10. MISCELLANEOUS INPUT AND INFORMATION

The correspondence in this section was sent to NBS at various times and is not associated with any particular workshop.

Representatives from the A.G.A. attended two of the recent workshop sessions on NBS Building Science Series 127 "Recommended Technical Provisions for Construction Practice in Shoring and Sloping of Trenches and Excavations," written as a basis for proposed changes to Subpart P of 29 C.F.R. Part 1926. Two of the potential changes discussed cause particular concern. First, consolidating excavation and trenching rules into a single regulation and, second, comments proposing a 3 foot set-back for excavations.

TYPICAL Spot BRACING FOR 10FT. Deep TRENCH USING HYDREULIC SHORES

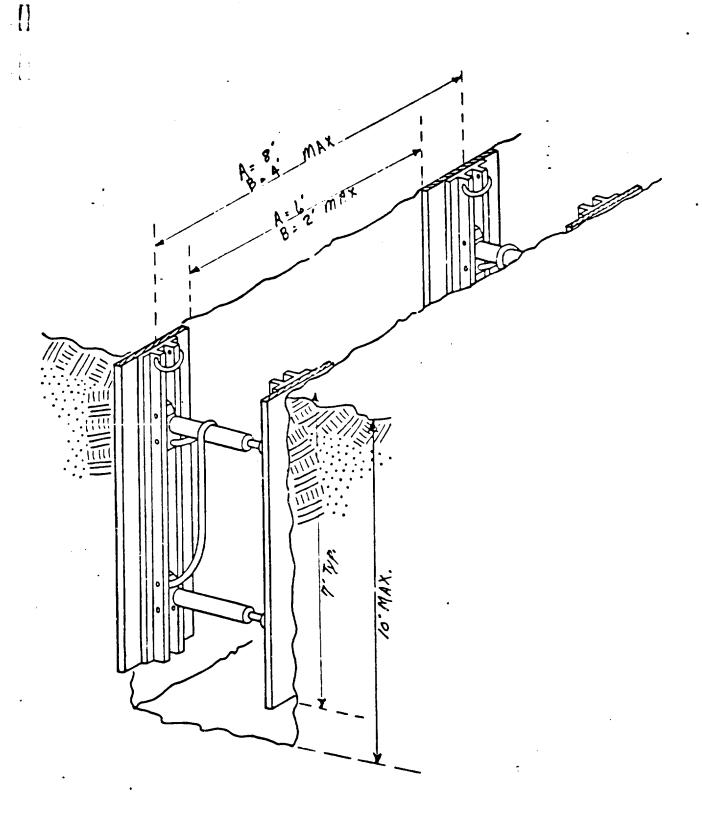
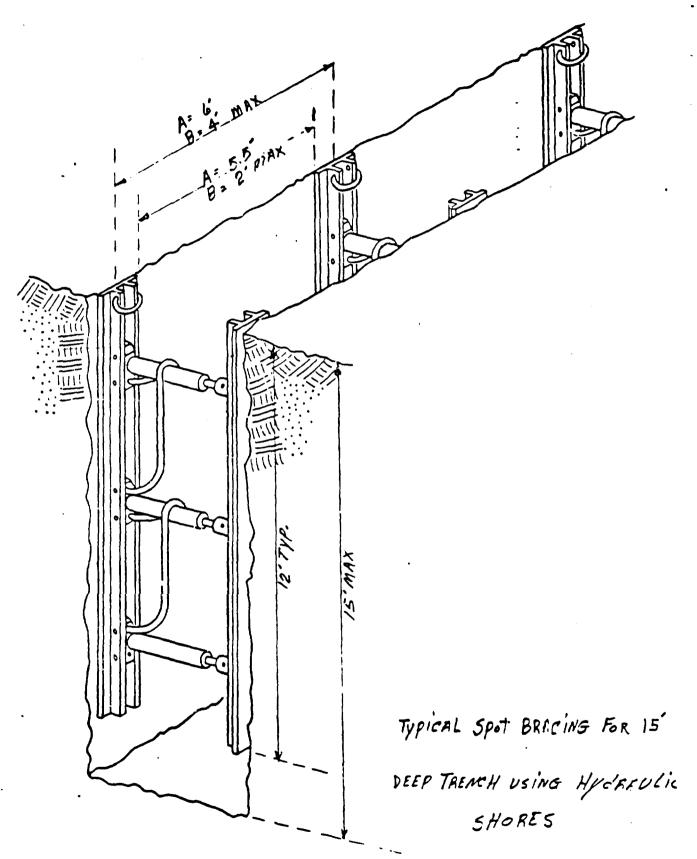
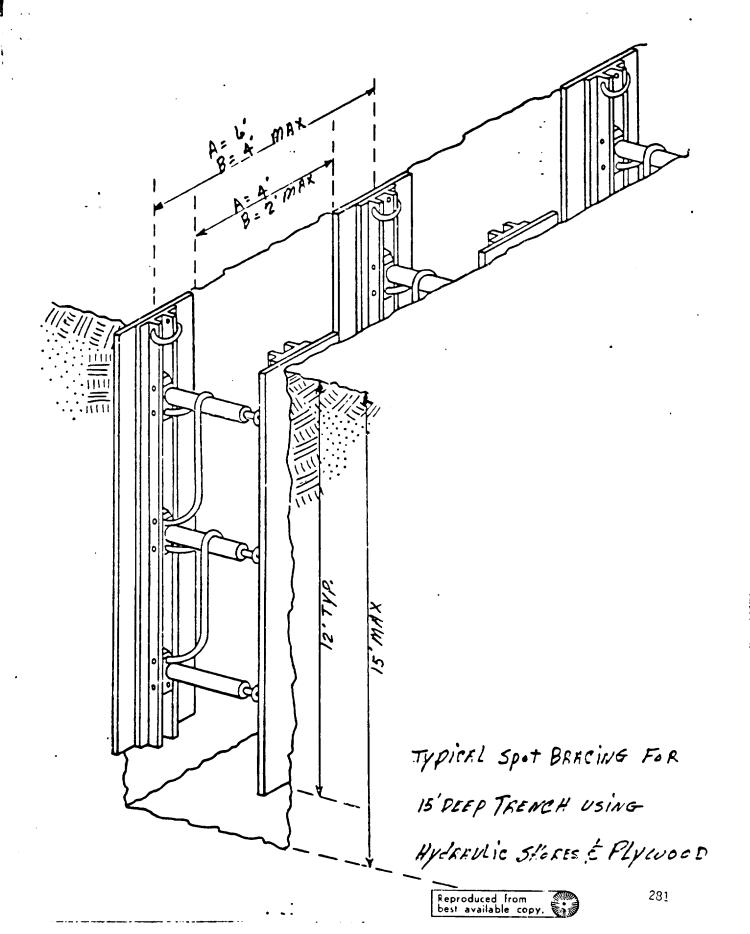
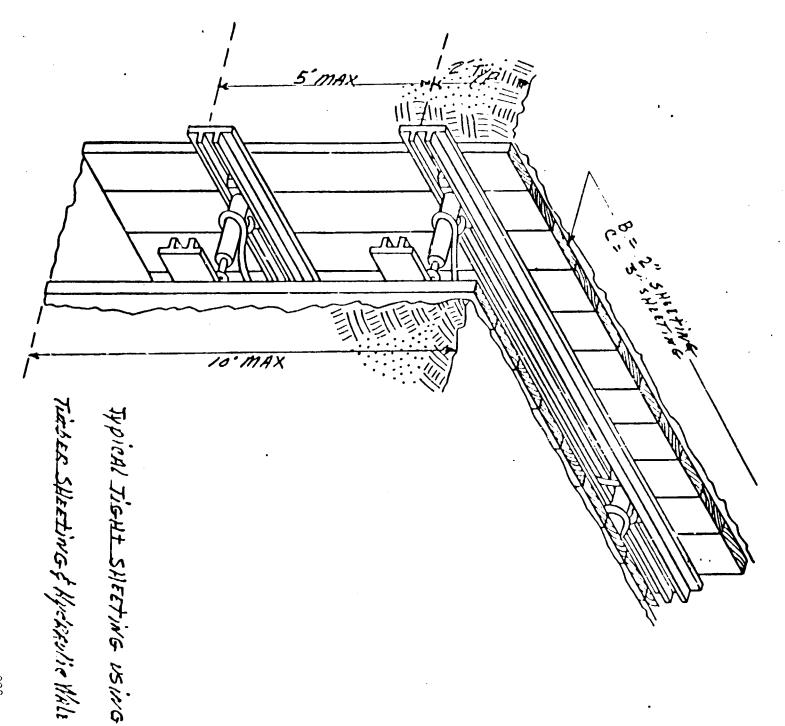
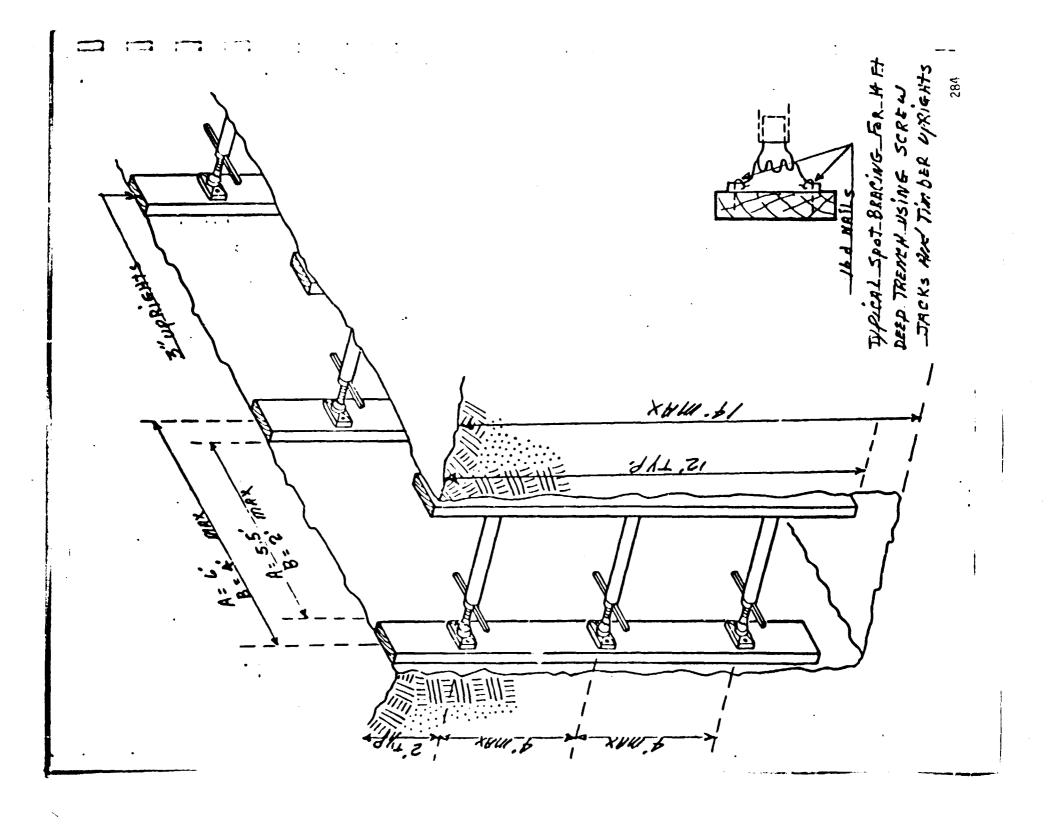
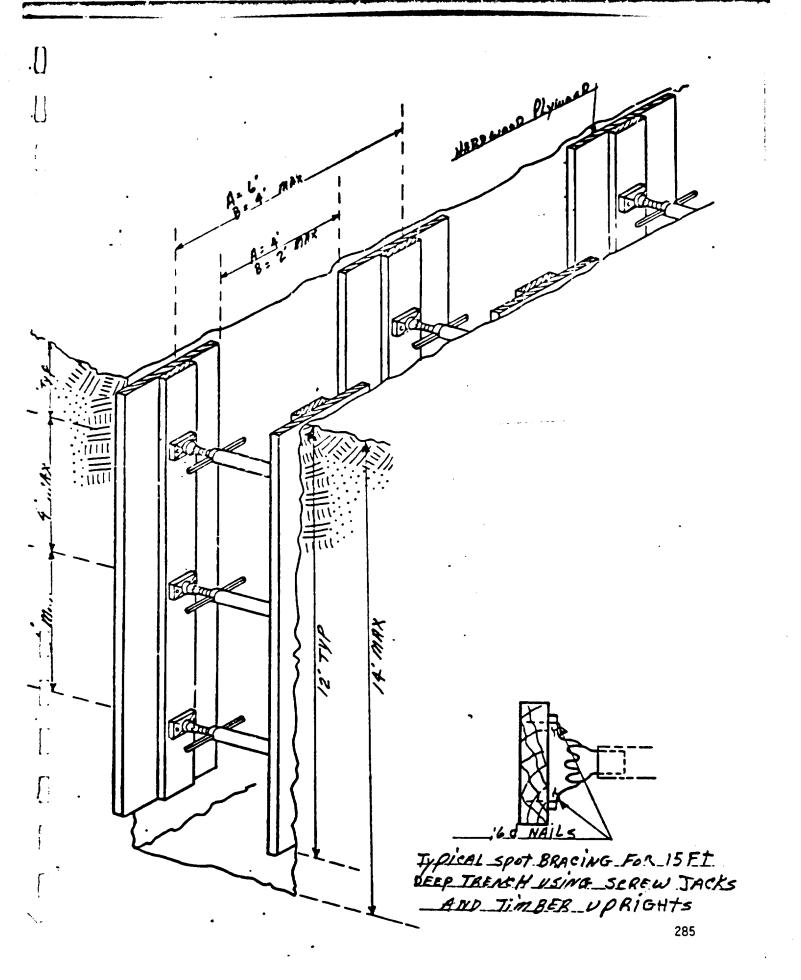
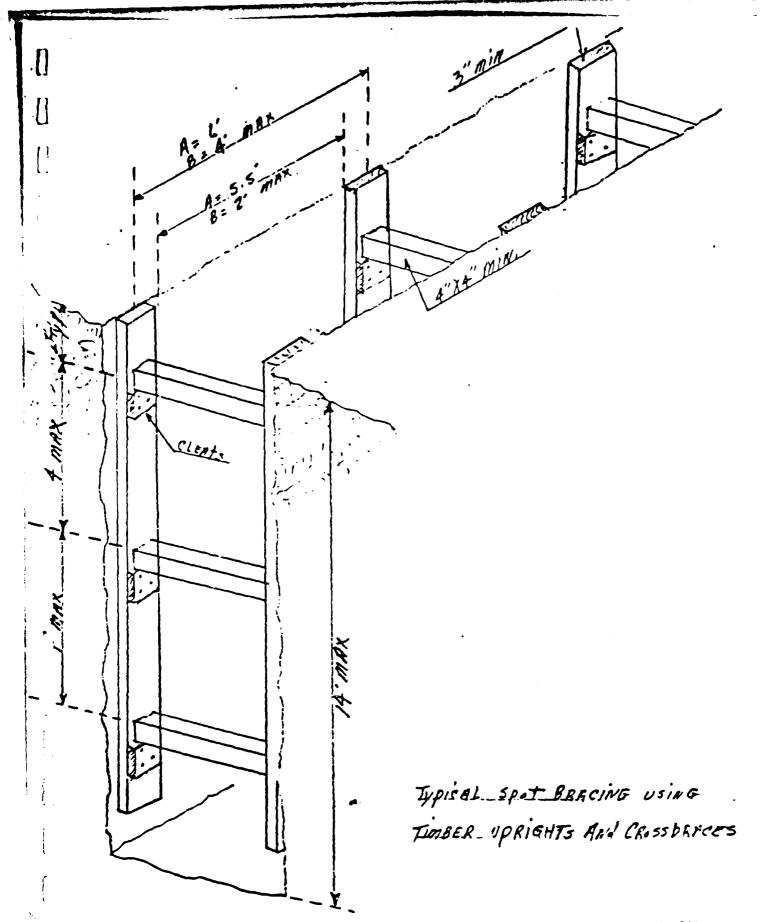
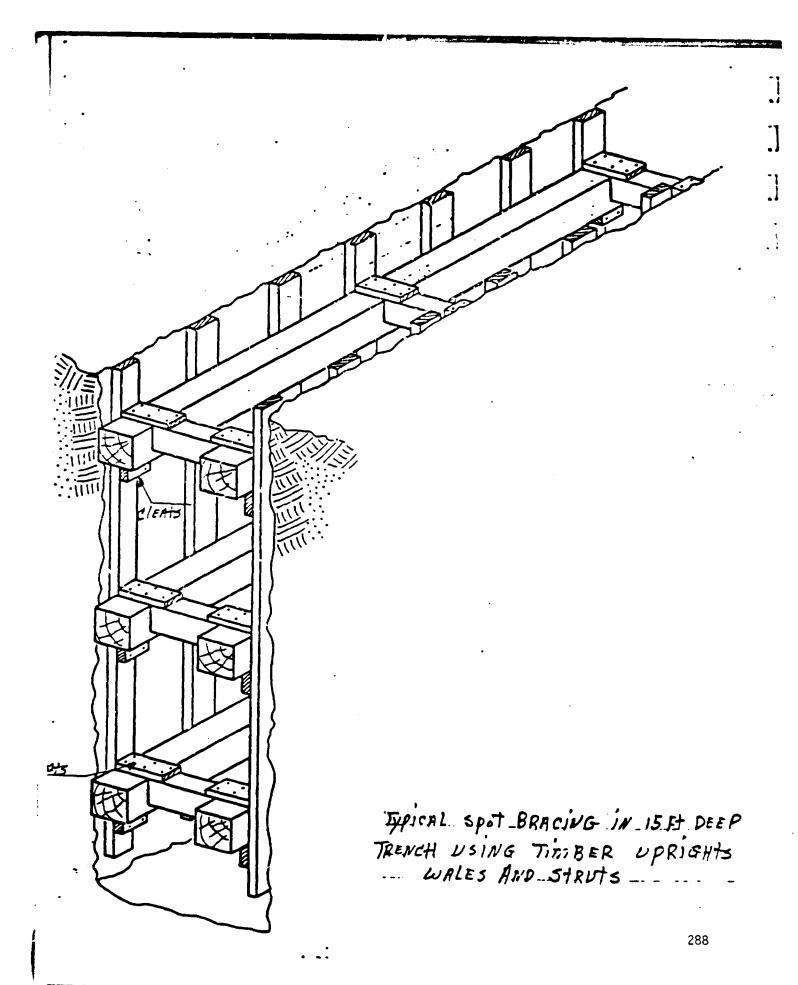
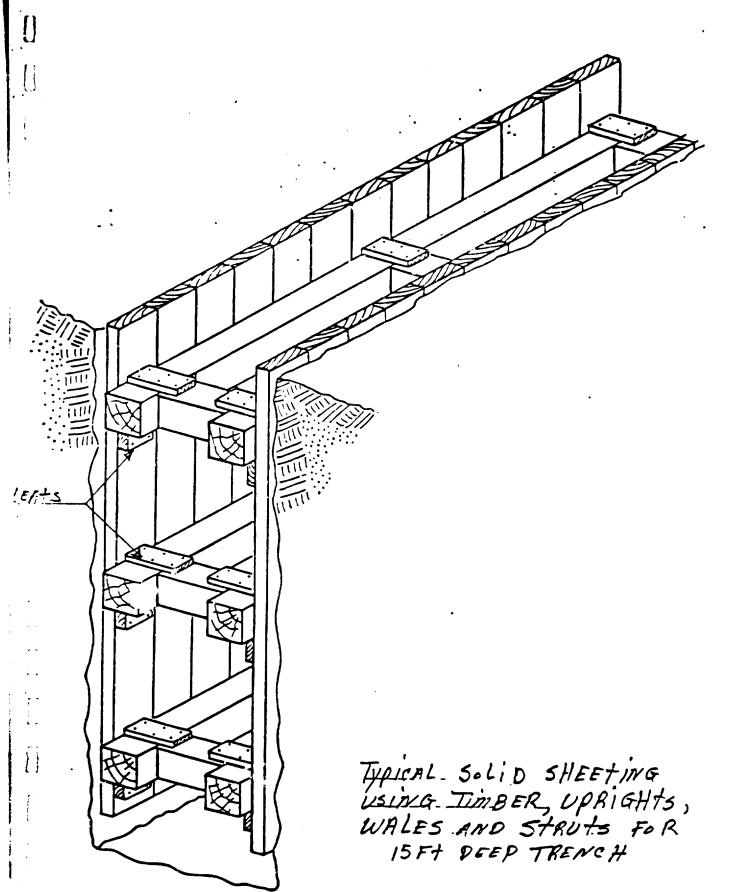
I think the guide lines fall somewhat short because you did not include isometric drawings to cover good trench shoring and bracing practices. I have prepared the enclosed drawings and recommend they be included with the documents.
